Marin County Flood Control and Water
Conservation District
**Corte Madera Creek Flood Risk Management
Project, Phase 1**
Final Environmental Impact Report
Volume 1: Comments and Responses to Comments
State Clearinghouse No. 2020080353

**Marin County Flood Control and Water
Conservation District
Corte Madera Creek Flood Risk Management
Project, Phase 1
Final Environmental Impact Report
Volume 1: Comments and Responses to Comments
State Clearinghouse No. 2020080353**

Figure 3.15-3 Utilities and Service Systems in the Project Area (Maps 3 of 3)

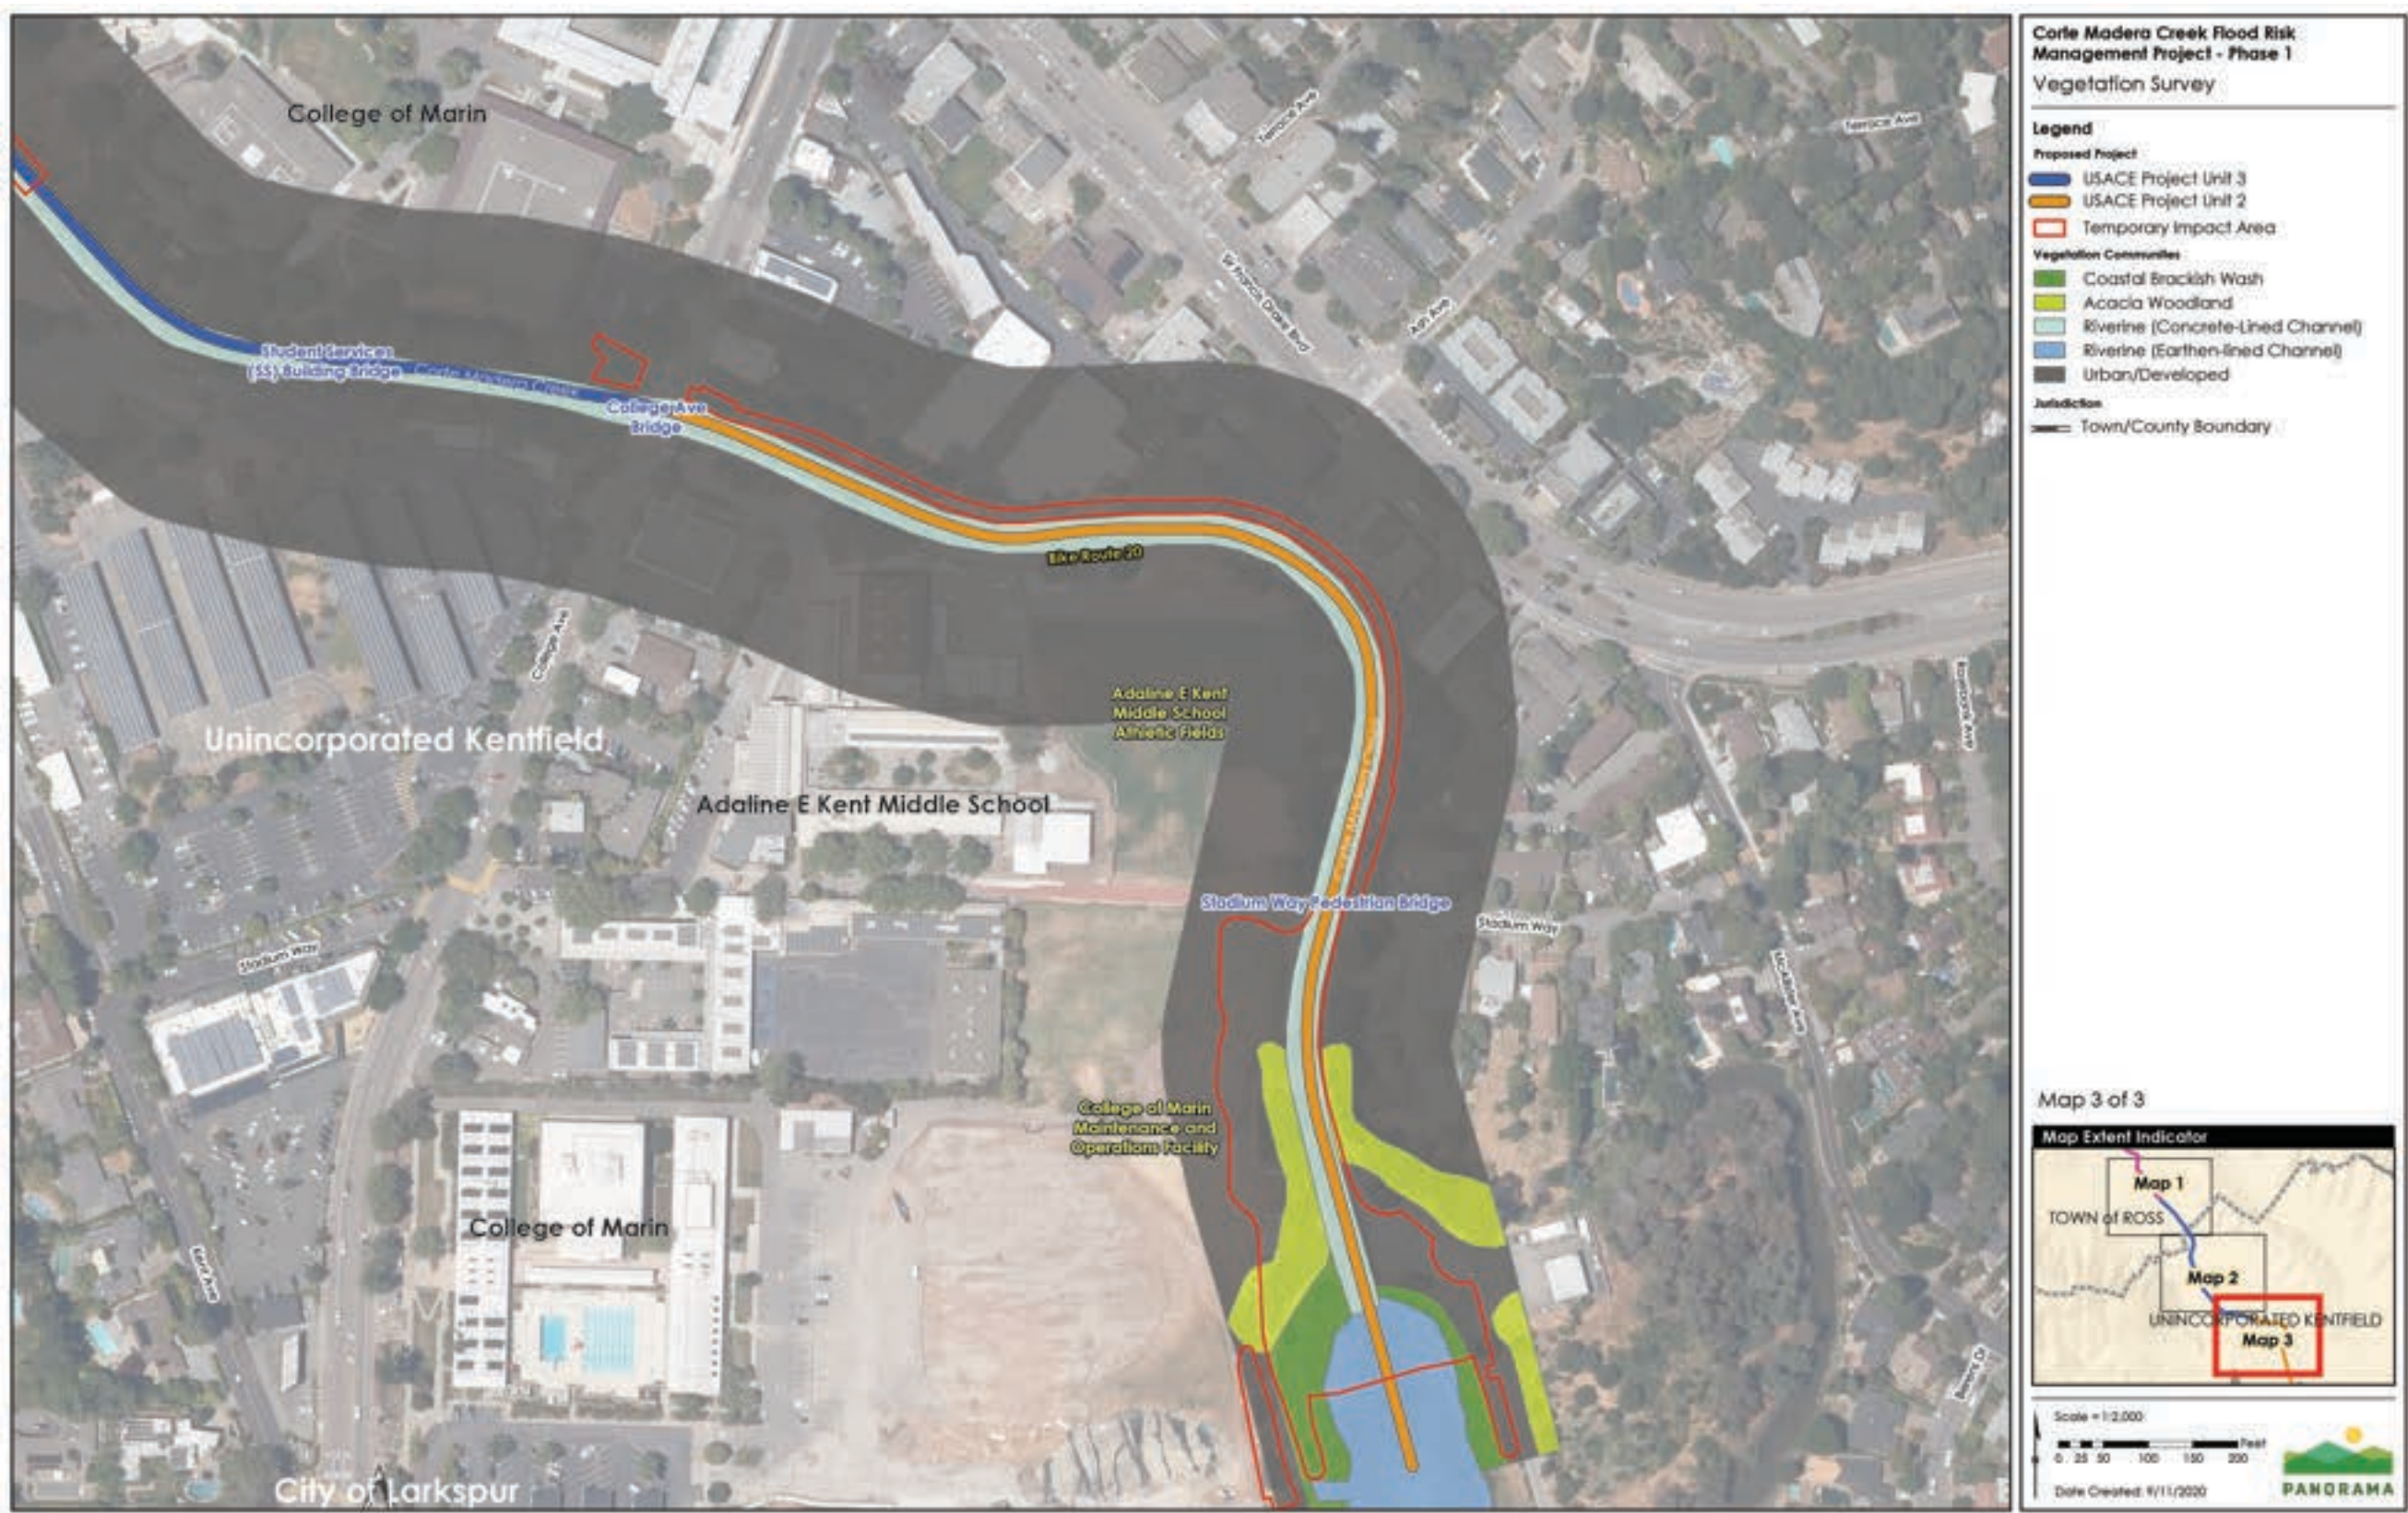
The first full paragraph on page 3.15-2 states: "An aboveground sewer pipe crosses the creek on the pedestrian bridge at the end of Stadium Way (Figure 3.15-3)." The sewer is a deeply buried pipeline that crosses the creek in an inverted siphon. The aboveground pipeline is a water distribution line.

The legend refers to MMWD stormwater lines. This is inaccurate: MMWD supplies treated domestic water; towns and the District are responsible for stormwater. The Design Basis Report (GDG 2020) describes utilities in the Lower COM project area, most of which are not shown accurately on Figure 3.15-3. Also, the outline of the Lower COM project area is inaccurate. It shows two areas that should be removed from the figure: the inaccurate staging area and an area on the left bank that has since removed from the project. Please use the most recent 65% designs.

Figures 2.6-1, 3.3-3, 3.9-3, and 3.15-3 have been revised as follows to show the correct footprint for the Lower College of Marin Project. These maps do not include a staging area at the location of a turn-around for emergency vehicles required by the Kentfield Fire District nor a planted area beyond the multi-use path on the left bank of the creek:

Figure 3.9-3 Floodway and Tsunami Inundation Zones

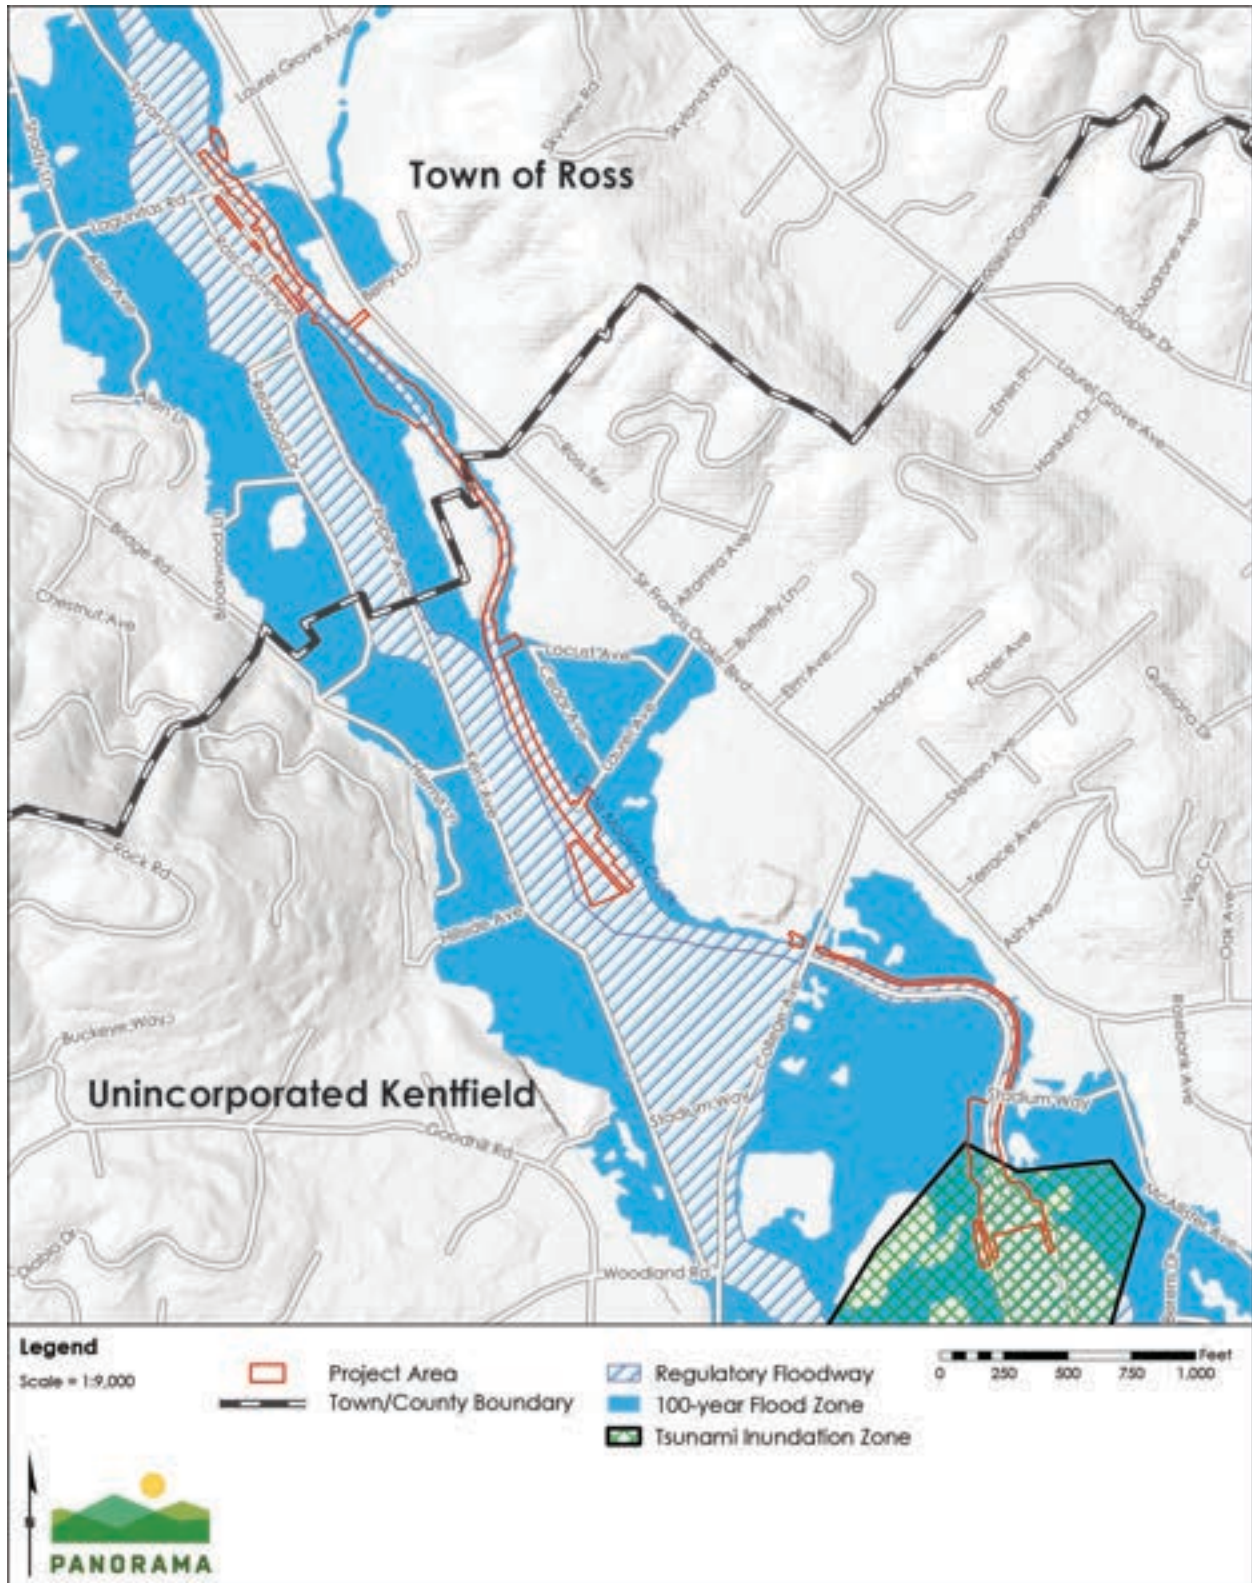
Figure 2.6-1; Figure 3.3-3; Figure 3.9-3 Remove staging area shown in COM project area. See Sheet C17 of 65% design plans for designated staging area.

Figures 2.6-1, Figure 3.3-3, and Figure 3.9-3 in the Draft EIR have been revised to remove the staging area shown in the College of Marin Project area as shown in response to B1-25 above.

In response to comments B1-25 and B1-31, Figure 3.9-3 in the DIER (page 3.9-18) has been revised as follows:

Figure 3.2-2 Sensitive Receptors within 1,000 Feet of the Project Area

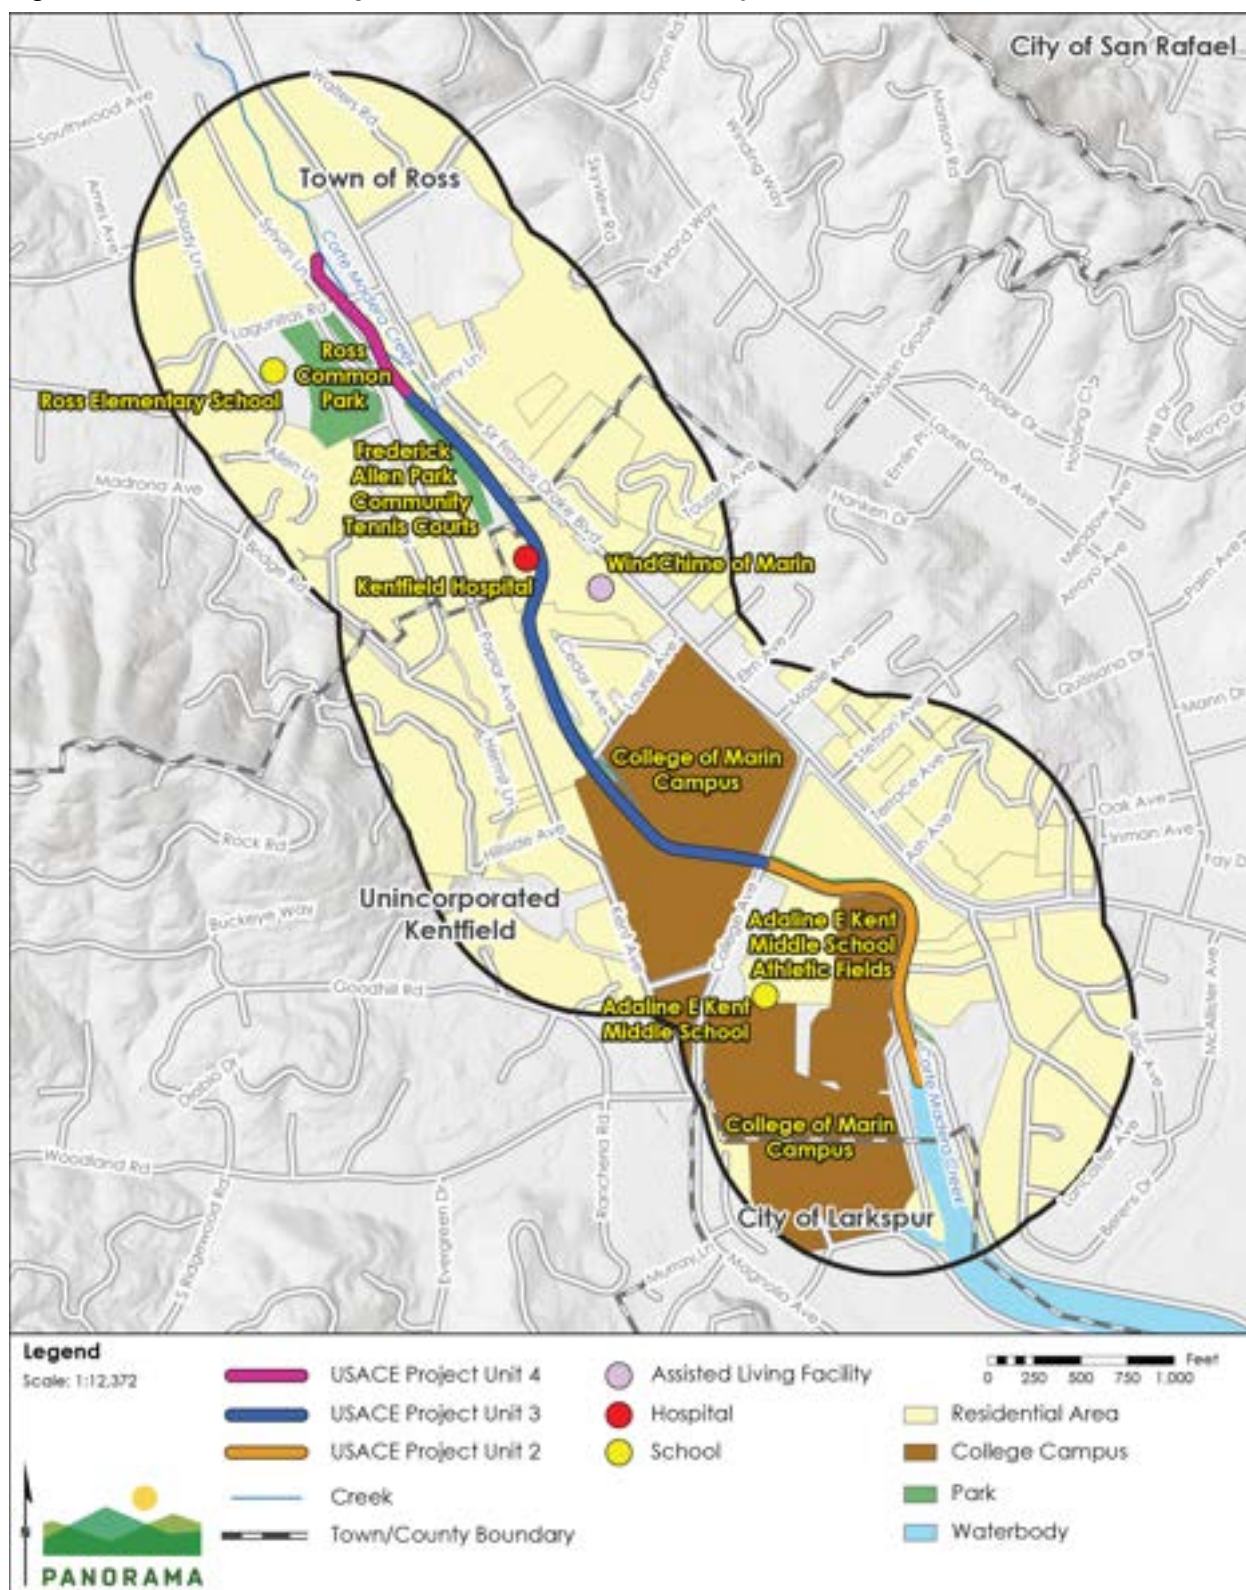
Figure 3.2-2; Figure 3.10-3 The site of COM's M&O Facility is mapped as Park (green). It should be mapped as College Campus (brown).

- B1-33 The commenter states that the College of Marin's Maintenance and Operations Facility is mapped as Park (green) and should be mapped as College Campus (brown) in Figure 3.2-2 and Figure 3.10-3 in the Draft EIR.

Figure 3.2-2 and Figure 3.10-3 have been updated as follows in the Draft EIR, to map the College of Marin's Maintenance and Operations Facility correctly as College Campus:

Figure 3.12-2 Parks and Recreational Facilities in the Project Area

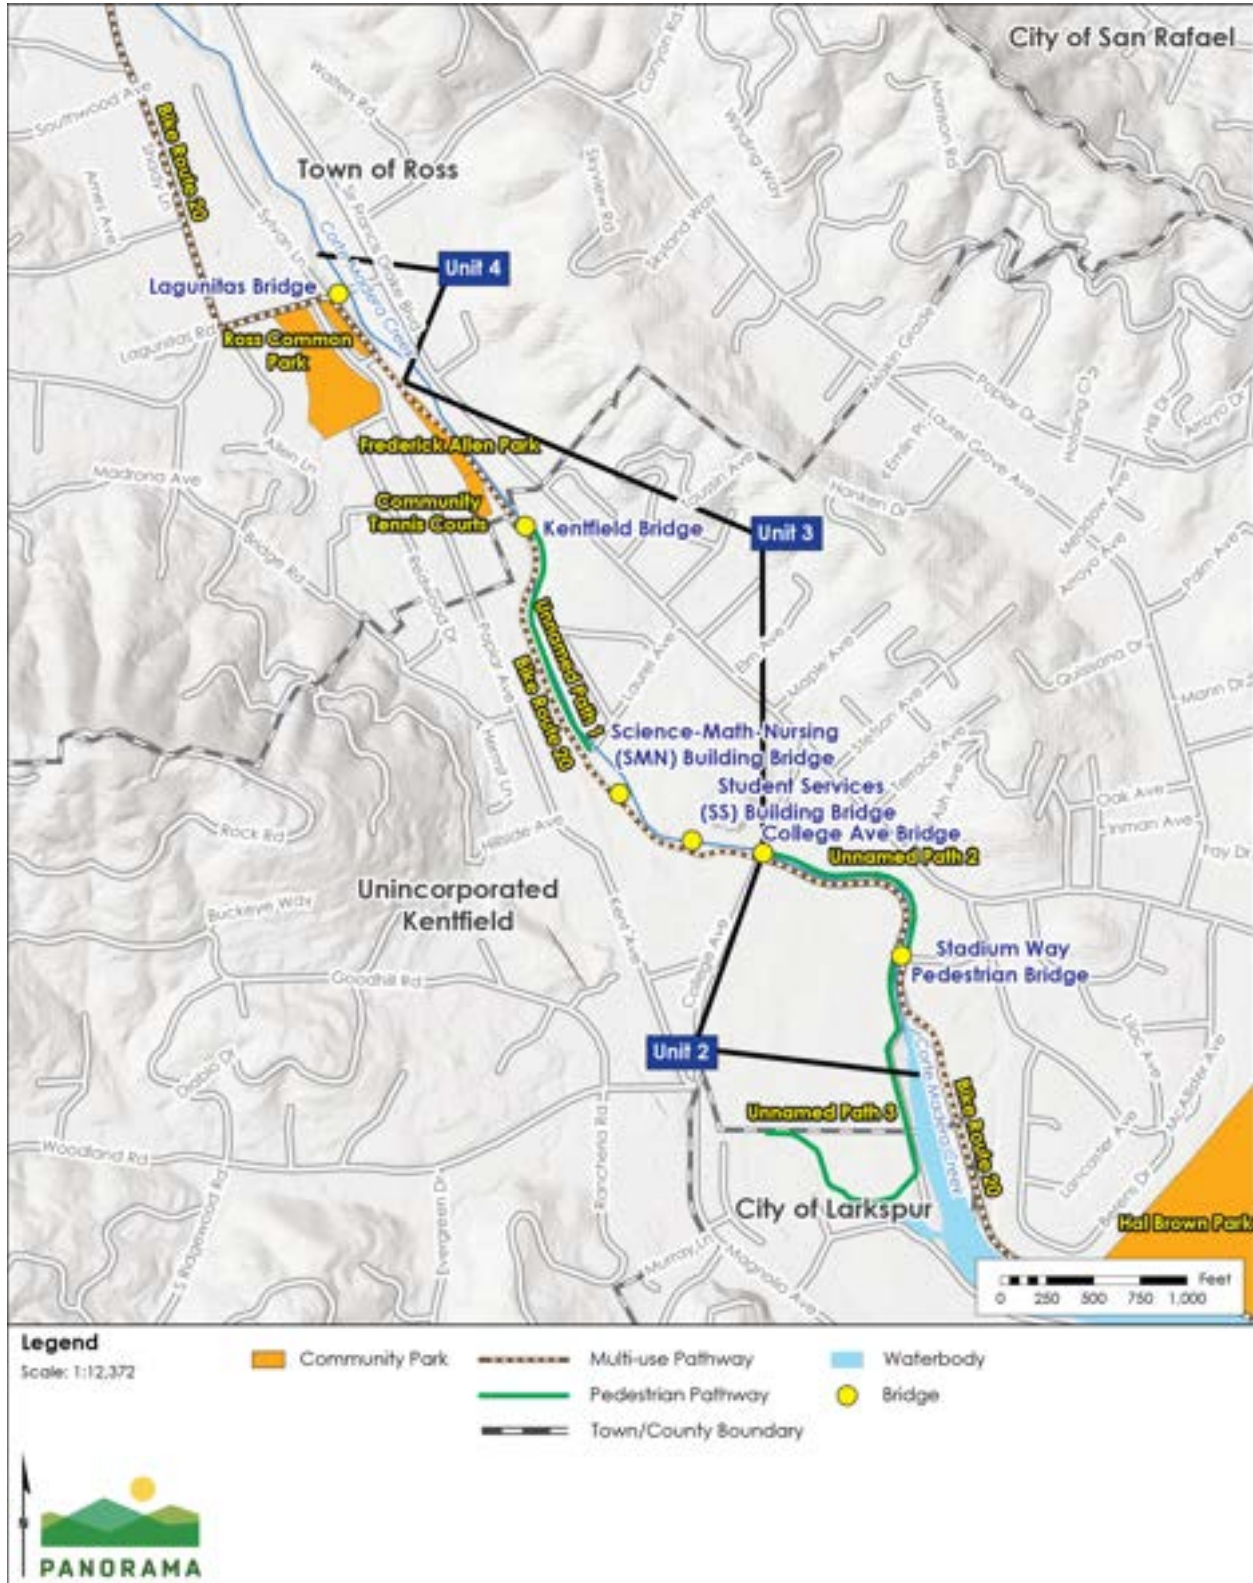
Figure 3.12-2 The COM M&O Facility is mapped as a campus recreation area. Remove that area from the map of recreational facilities.

B1-43 The commenter states that the College of Marin Maintenance and Operations Facility should be removed from Figure 3.12-2.

Figure 3.12-2 has been revised in the Draft EIR as follows, removing the College of Marin Maintenance and Operations Facility.
